**CHANGE ORDER REQUEST SUMMARY**

PROJECT : Spring Lake Park City Hall Renovation / Expansion

# Proposal Request

PROPOSAL REQUEST NO: 10  
DATE: 7/15/2024  
PROJECT NO: 193806049  
CONTRACT FOR: Building Construction

PROJ. NO.: 193806049  
 SHEET NUMBER: A403

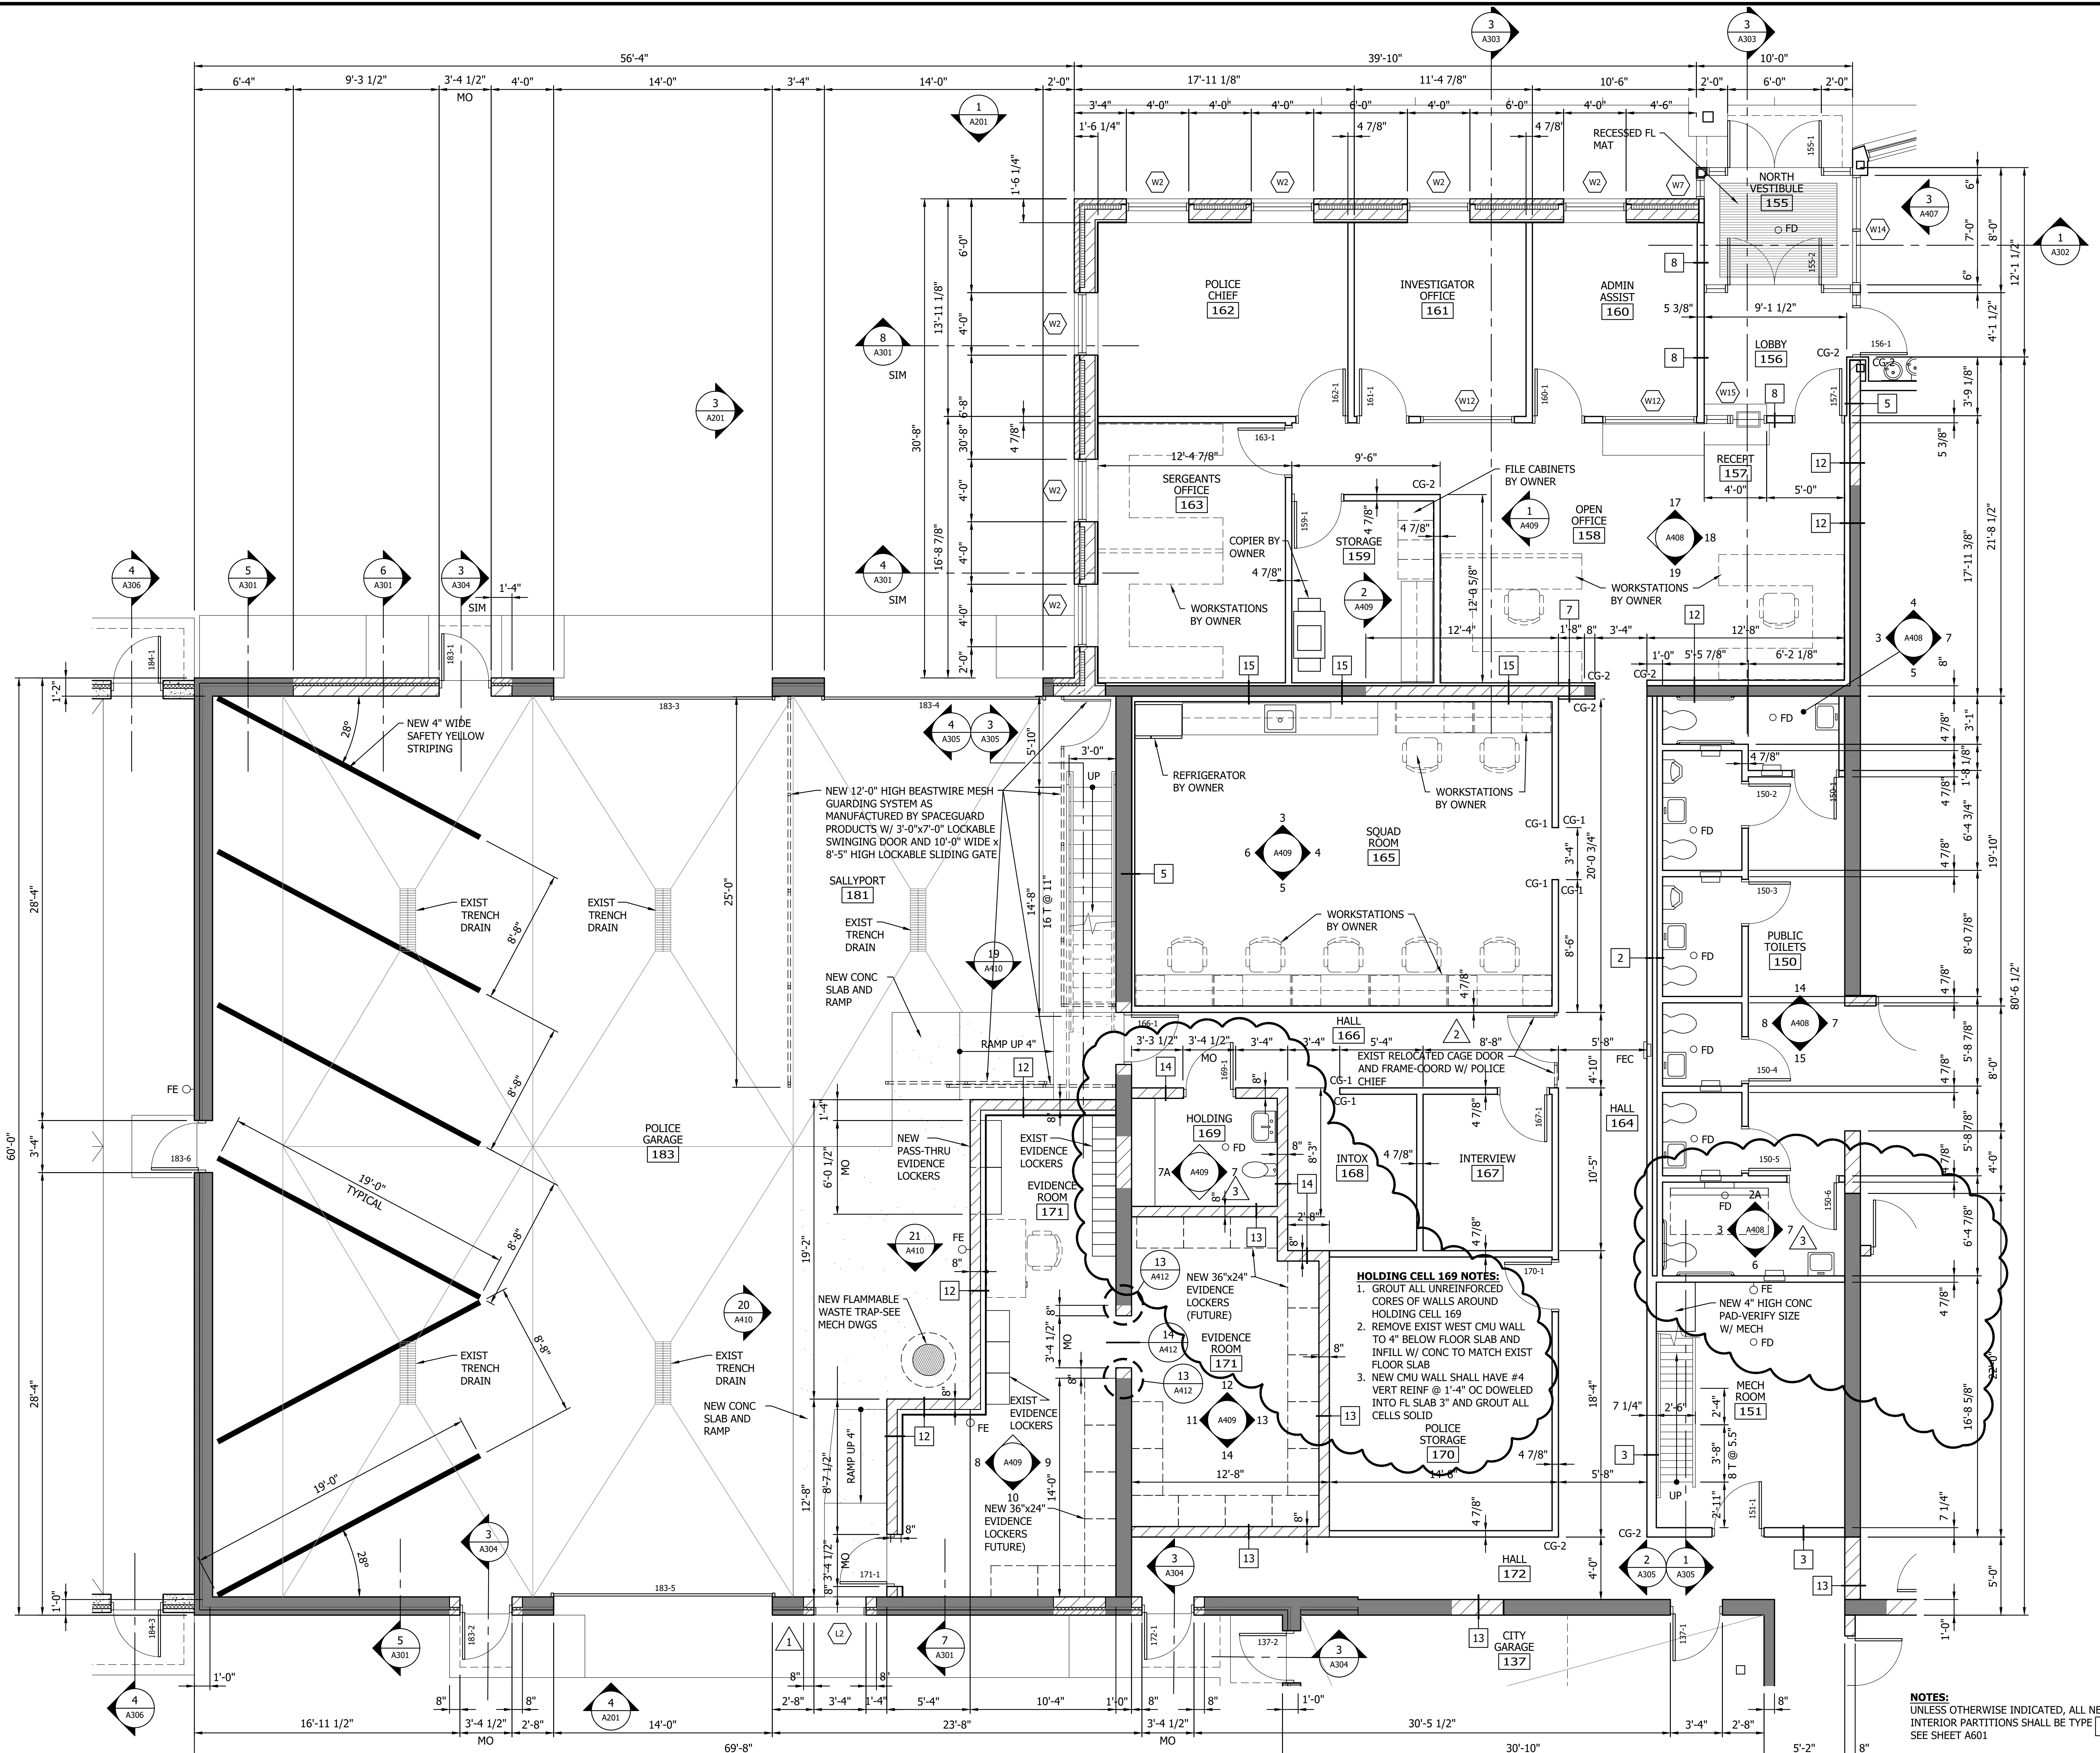
1. Revise floor plan to add note to grout all unreinforced cores of walls around Holding Cell 169. This item applies only to the north, east, and west walls.

1. Revise floor plan to relocate west wall of Holding Cell 169 as indicated.
2. Add notes as indicated for west wall removal and construction.

1. Revise floor plan to relocate wall-mounted bench on the north wall of Holding Cell 169 as indicated.

1. Revise floor plan to relocate adult changing station from south wall of Public Toilets 150 to the east wall of the accessible toilet room as indicated.
2. Revise floor plan to relocate sink to west wall of the accessible toilet room as indicated.
3. Revise floor plan to move west wall of the accessible toilet room 2" further west as indicated.

PROJ. NO.: 193806/9-469-2149  
 SHEET NUMBER: **A409**

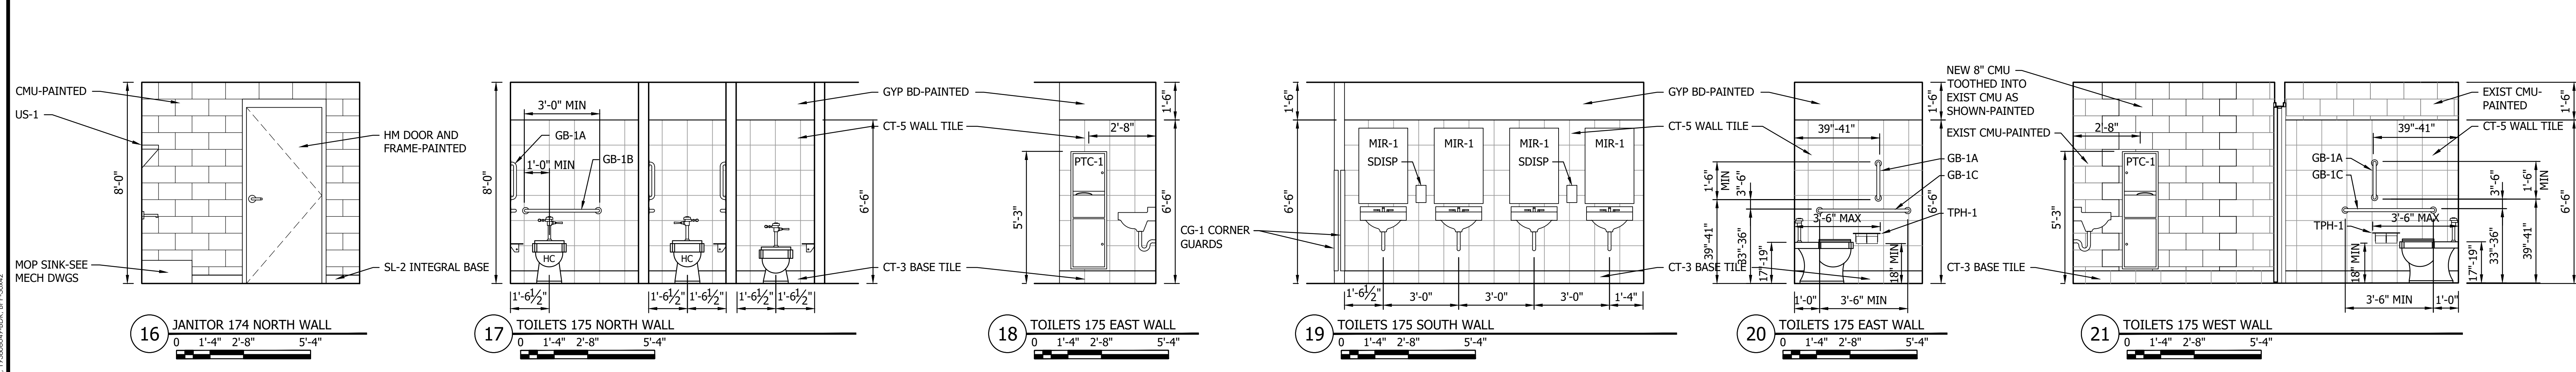
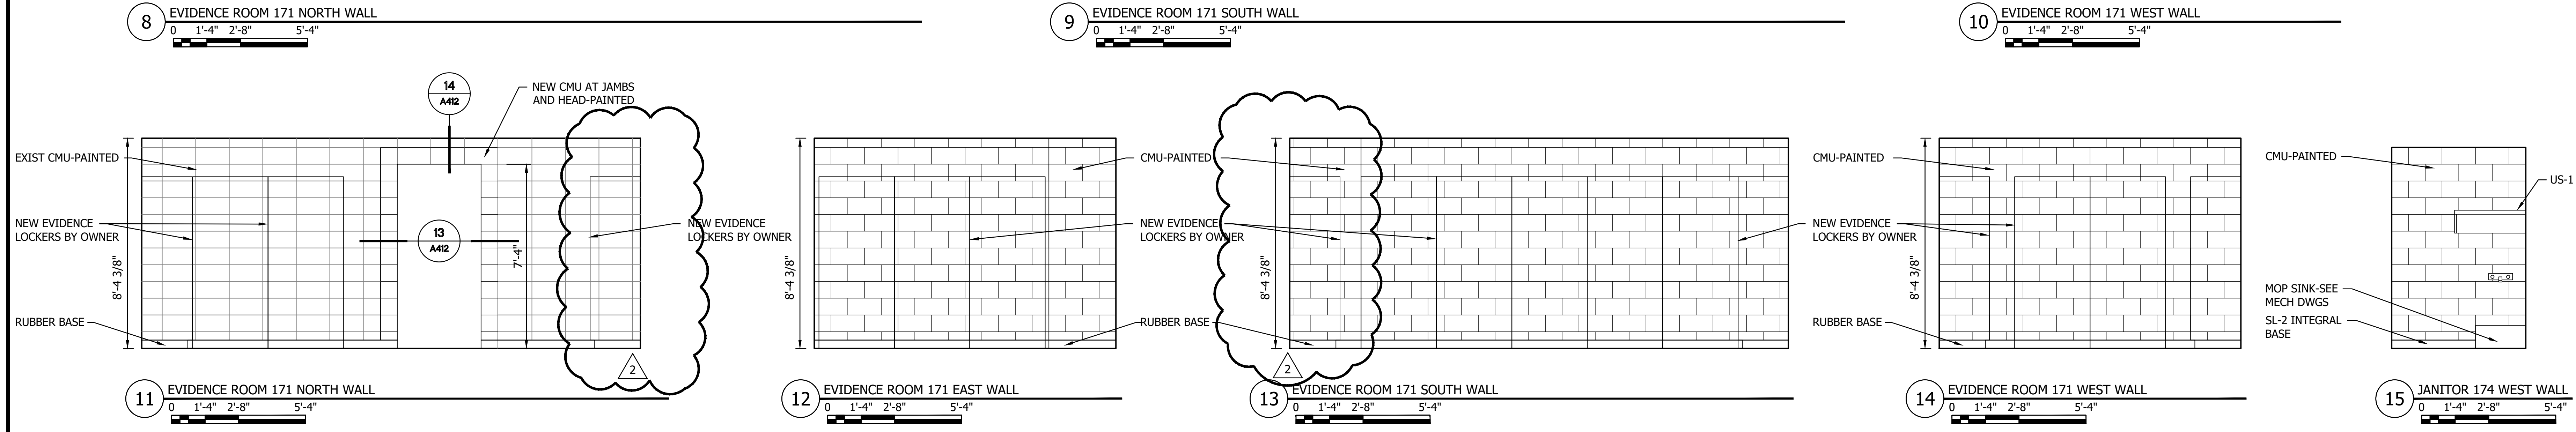
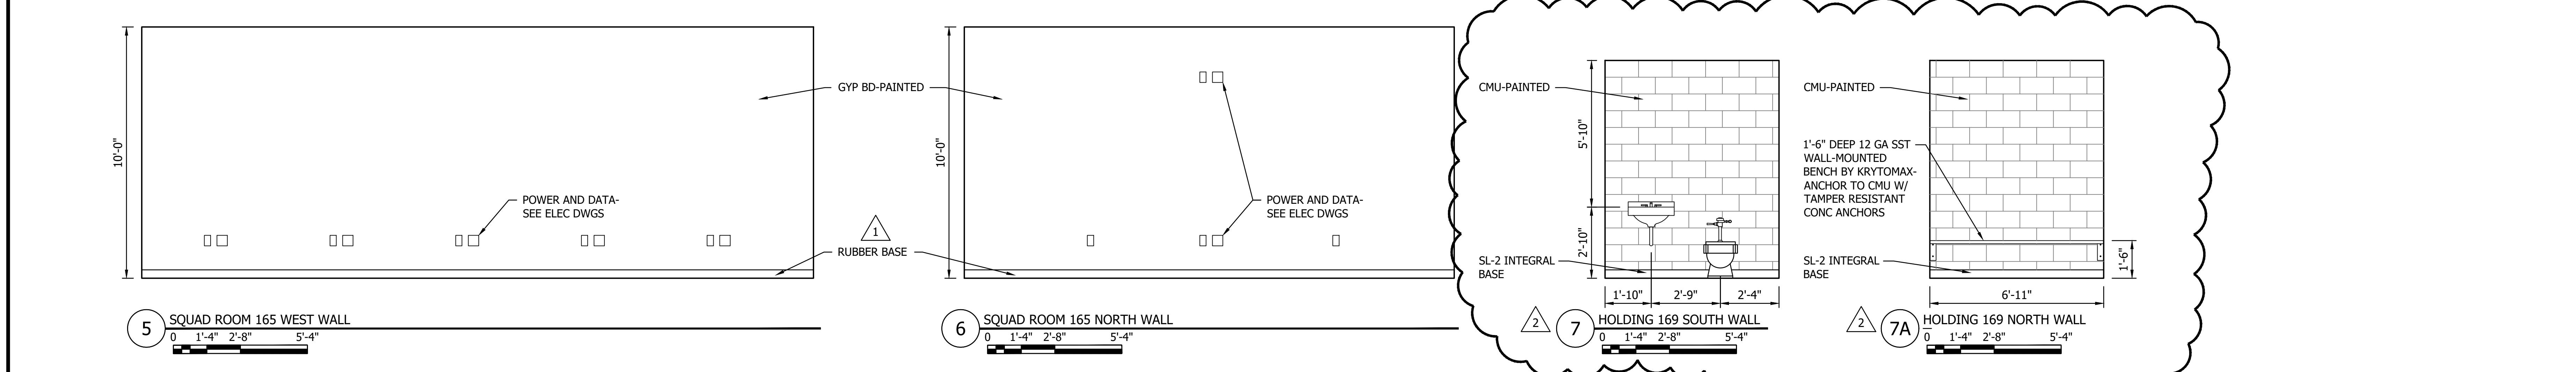
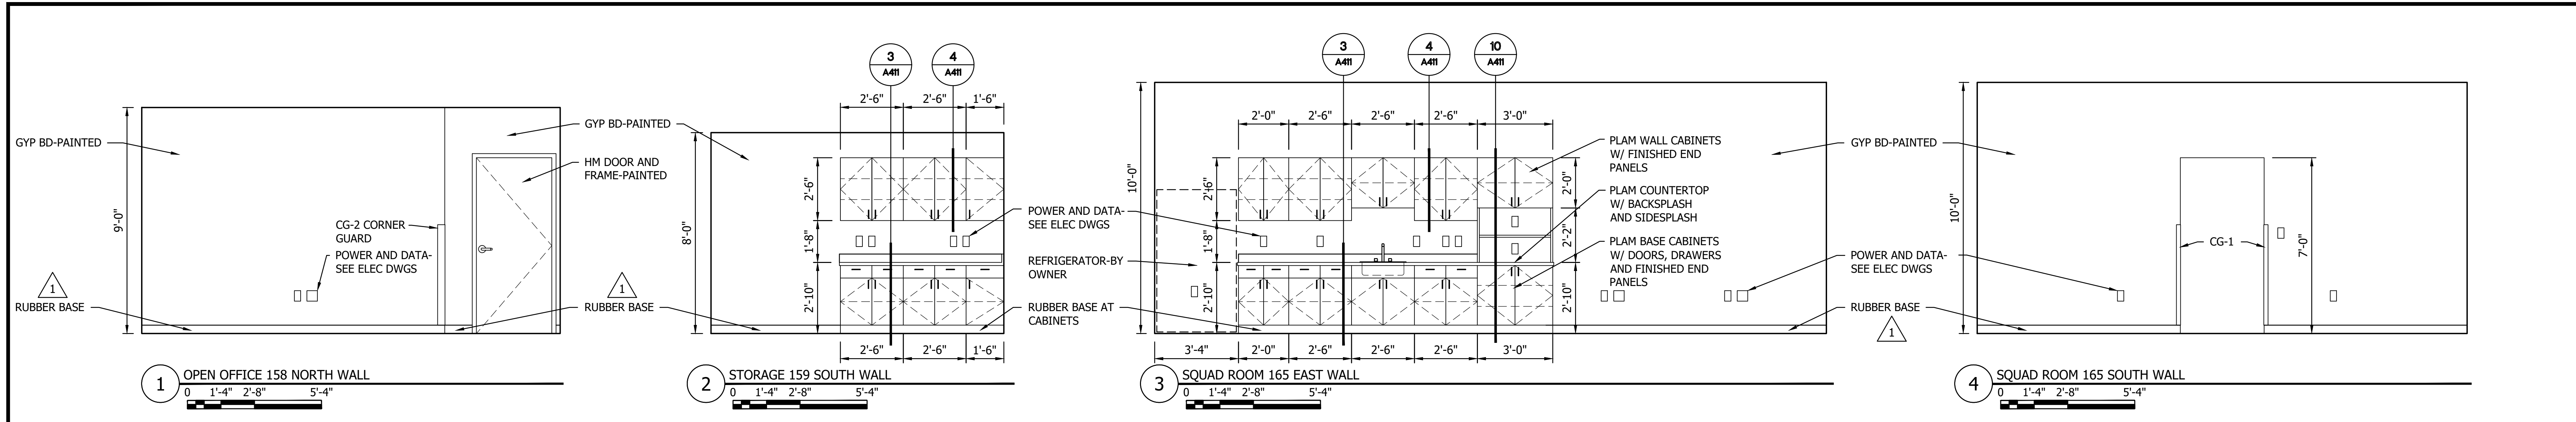
1. Holding Cell 169 South Elevation 7: Revise width of room as indicated.

1. Holding Cell 169 North Elevation 7A: Add new elevation showing wall-mounted bench as indicated.
